DEPARTMENT OF THE AIR FORCE
HEADQUARTERS UNITED STATES AIR FORCE
BOLLING AFB DC 20332

SUBJECT Notification of Change (USNRC License STB-1407)

1 Atch
Sketch of Location Change
in Building 3001

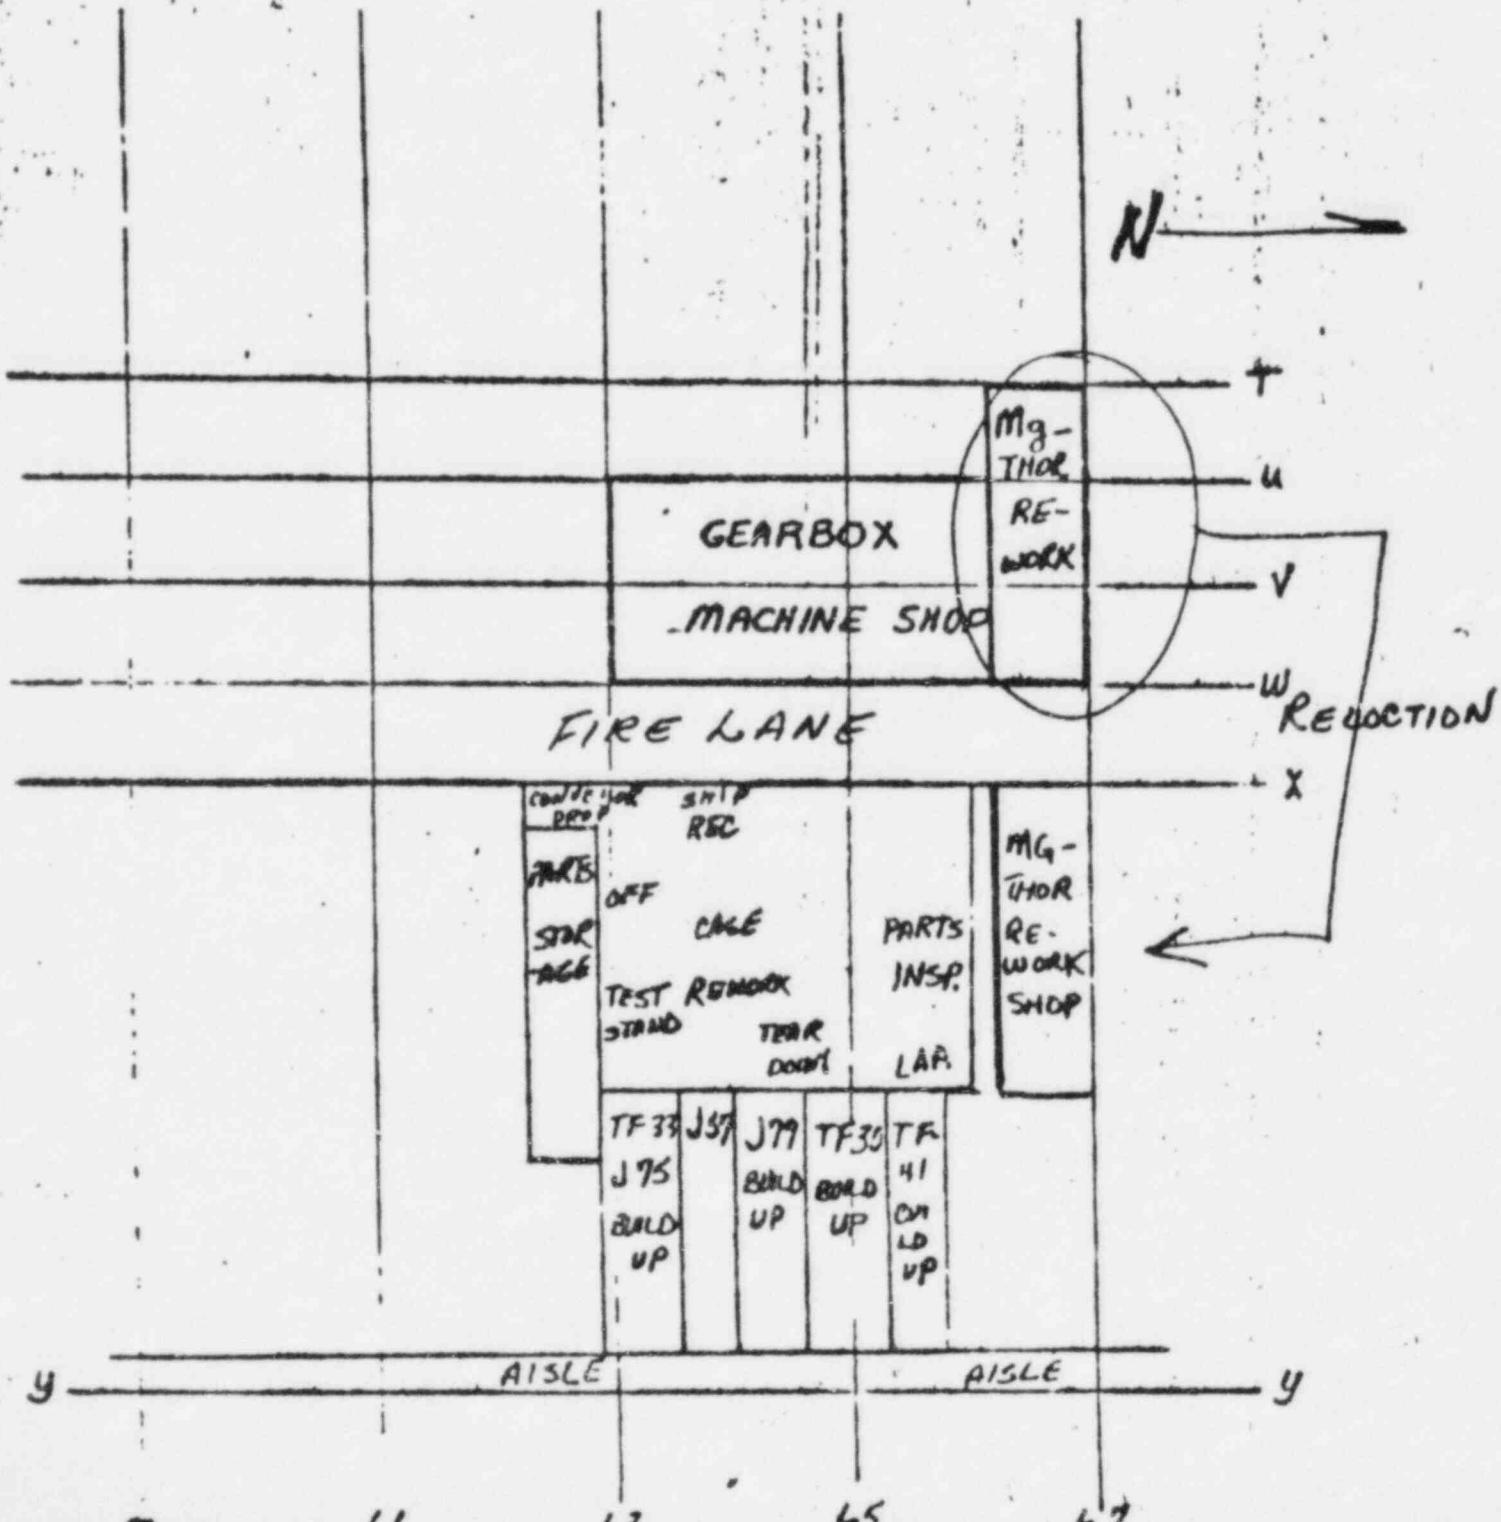
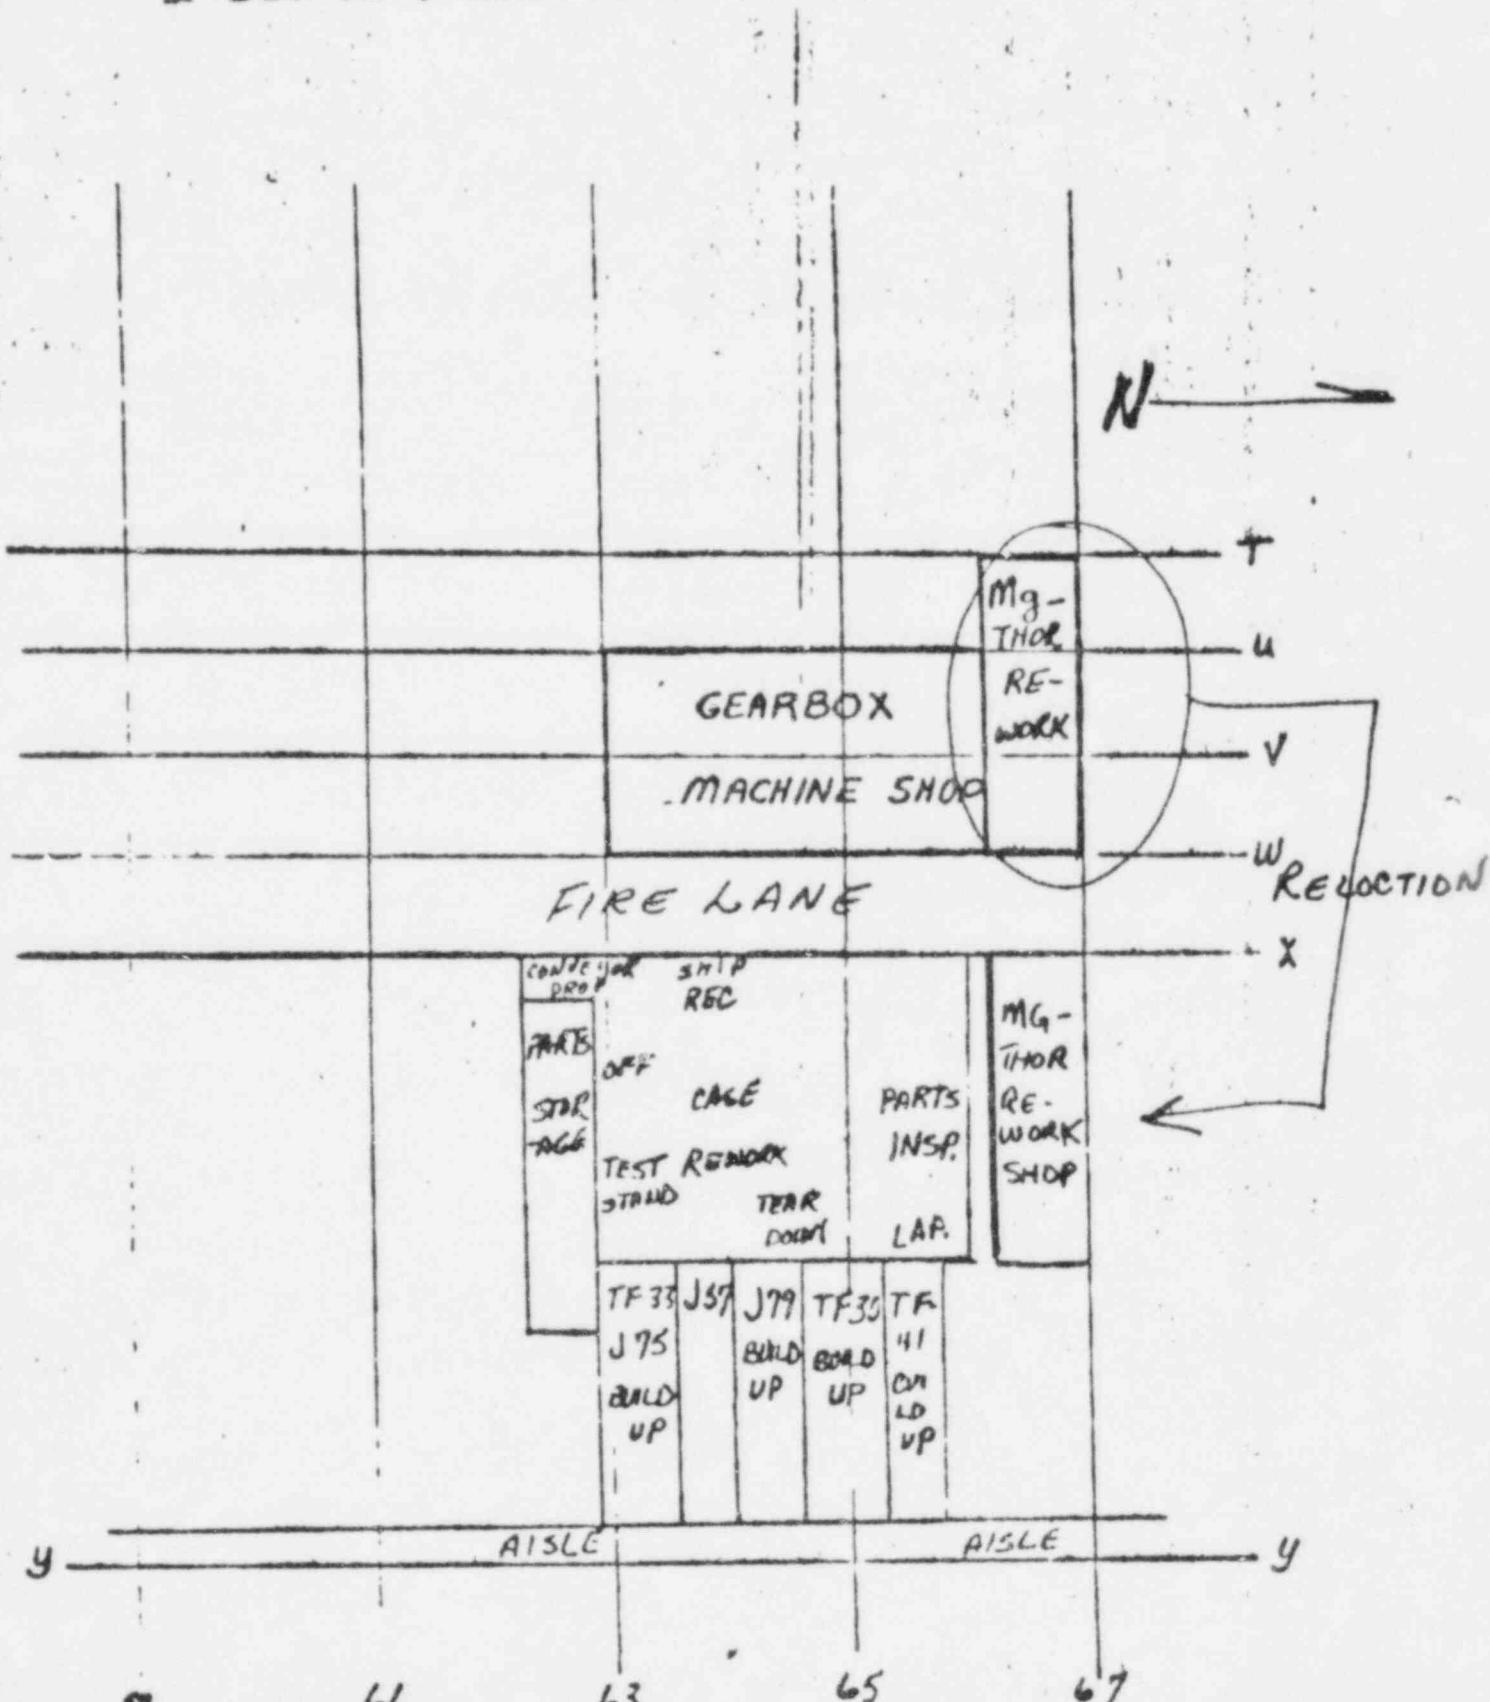
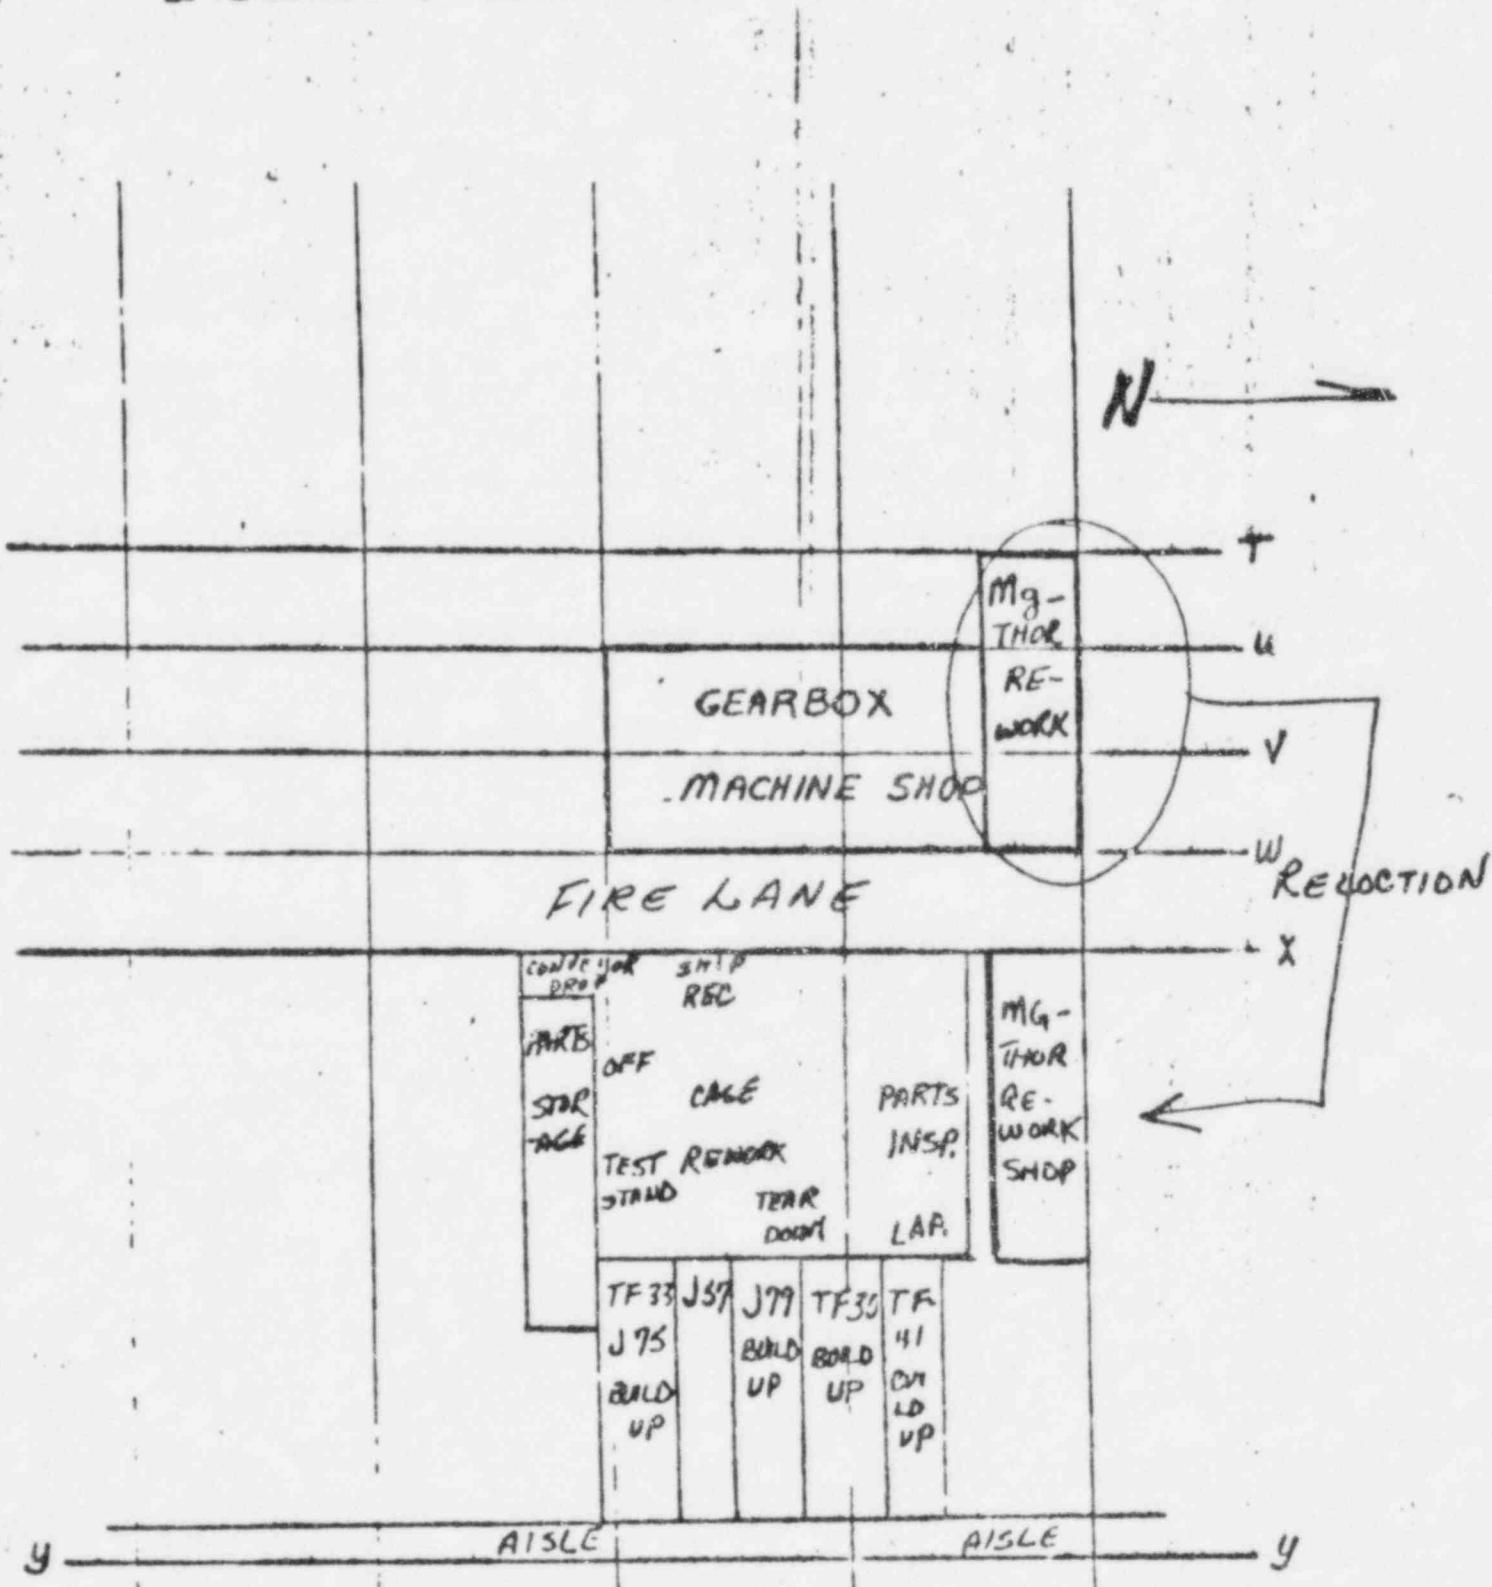
1. This is to advise you of a change in the planned location for repair/rework of magnesium-thorium components authorized by license number STB-1407 issued February 22, 1982 to the Directorate of Maintenance, Tinker Air Force Base, Oklahoma.
2. The gear box repair/rework was to have originally been conducted within an enclosure constructed in area T-67-W-67 of building 3001. Subsequent plant layout modifications now require this enclosure to be located in area X-67-Y-67 within the same building. This relocation is illustrated on the attached diagram. Since no work has yet been started, this simple relocation does not change any radiological health considerations of this license, nor any other representations made in the original application dated October 13, 1981.
3. Please refer any subsequent correspondence on this subject to this office.
